# Memorandum

**Re:** Pumping Zone of Influence Clarified Relative to DEIR Claims.

**Exhibit 1/Figure 3-5**  
**P6L and P5L Vertical Gradient Across Riverbed**  
 El Sur Ranch  
 Big Sur, California

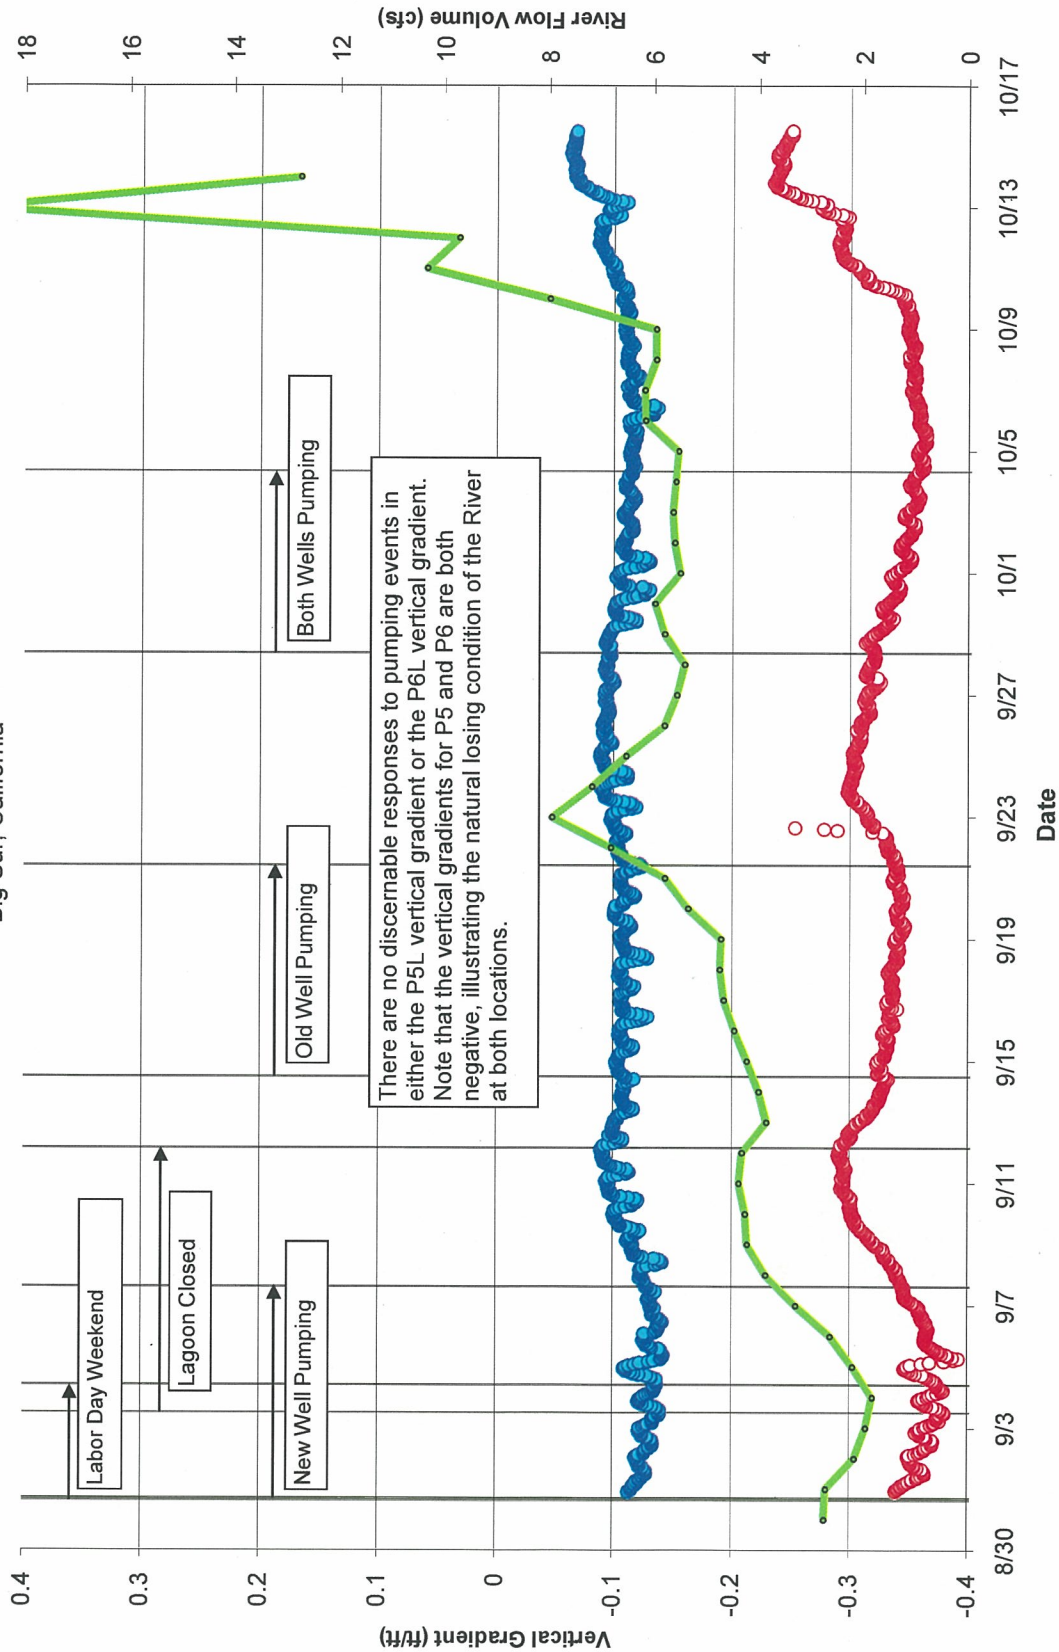
In our 2007 and 2008 Technical Reports, SGI concluded that the irrigation well pumping Zone of Influence (ZOI) extended approximately 1,000-feet upstream of the New Well location. This was based on measured groundwater drawdown in surrounding monitoring wells and in piezometers placed in the Big Sur River when both irrigation wells were pumping at a combined rate of approximately 5 cfs. The Draft Environmental Impact Report (DEIR) prepared by PBS&J suggests that our data actually shows that the ZOI extends as much as 1,600-feet upgradient of the New Well Location. The only evidence used to support the extended ZOI is Figure 3-5 of our 2008 report suggesting:

“... during the 2007 study (Critical Dry irrigation season conditions), at distances of up to about 600 feet upstream of the expected ZOI, the groundwater gradient became more negative when both well [sic] were pumping and dropped from about -0.31 ft/ft to -0.36 ft/ft (Figure 3-5 SGI 2008)”. (DEIR, p. 4.2-60).

There are several issues with the analysis performed and the conclusions reached related to the data included on Figure 3-5. These will be addressed below.

Figure 3-5 (included as Exhibit 1) does show a reduction in gradient at the P5 location on the order PBS&J suggested in their analysis included in the DEIR. PBS&J assumed that the reduction in gradient was the result of pumping. In fact, at the point that both irrigation wells started pumping together at approximately 5 cfs (September 28, 2007), both groundwater and surface water elevation trends at the P5 and P6 locations INCREASED (see attached Exhibits 2 through 5) relative to the prepumping groundwater and surface water trends. Because the surface water elevations at both locations nearly stabilized (Exhibits 3 and 5) while the groundwater elevations continued to decline (Exhibits 2 and 4), the net effect was an increase in the negative gradient between the River and the underlying alluvial aquifer. The near stabilization of surface water levels is a strong argument that pumping activities were not the cause of the gradient change. It is most likely that surface water levels, which were declining following a rain event prior to the start of the pumping, leveled off as the River returned to baseflow conditions. The expected lag between the leveling out of surface water conditions relative to groundwater conditions (i.e. surface water leveled out before the groundwater

did, thus the gradient became more negative) resulted in an increased negative gradient which PBS&J attributed to pumping.

It was the increase in negative gradient at the P5 location that led PBS&J to the conclusion that the ZOI, which we identified as within a radius of 1,000-feet upgradient of the New Well location, was potentially an additional 600-feet further upgradient. The P5 location is approximately 90-feet upgradient of the SGI identified 1,000-ft ZOI. The P6 location, which on Figure 3-5 showed only a very slight increase in negative gradient, is approximately 275-feet upgradient of the 1,000-ft ZOI. There were no sensors beyond P6 to provide data regarding a change in gradient. Therefore, even if the change in gradient at P6 could be attributed to pumping of the El Sur Ranch wells, there does not appear to be a basis to extend the ZOI an additional 600 feet, which is 325 feet farther than the most distant piezometer location.

The conclusion is that the increase in negative gradient at the P5 and P6 locations was the result of natural River hydraulics in response to a rainfall event, as opposed to a reaction to ESR irrigation well pumping. The PBS&J assertion that the gradient between surface water and groundwater became more negative at the P5 location when the pumps were turned on is correct, but coincidental (unlike at the piezometer locations within the ZOI). The surface water and groundwater hydrographs at both the P5 and P6 locations show increases in water levels, which is not indicative of pumping related effects, but of natural hydraulic effects that took place at the same time as the onset of pumping.
